Modification Recommended Service Note

P5002A Keysight Streamline USB Vector Network Analyzer

Serial Numbers: From MY58100696 to MY58100732

Potential lifted front panel overlay

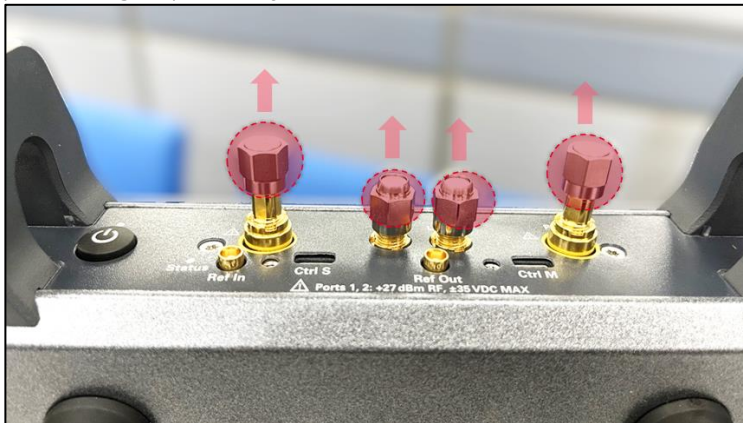
Keysight streamline series vector network analyzer (VNA) of serial number range identified in service note cover page might potentially exhibit the following lifted front panel overlay symptom.

Apart from cosmetic imperfections, the lifted front overlay could have led to non-fully attached *Ctrl S* micro-HDMI cable connector in multi-VNAs setup configuration.

-> Apply this service note only if end users' VNA is exhibiting the following symptom.

Procedure to replace the front panel overlay.

1. Remove the front handles. Detach the 50-ohm termination (LO-In, LO-Out, Port 1 & Port 2) or protecting caps if they are attached to the VNA.

2. Pry open the existing front panel overlay and remove it from front panel.
3. Clean the metal surface thoroughly and ensure it is free of adhesive residue.
4. Affix the new self-adhesive front panel overlay onto the metal surface.
5. Reinstall (reuse) the 50-ohm terminations or protecting caps accordingly.

6. Reinstall (reuse) the front handles.
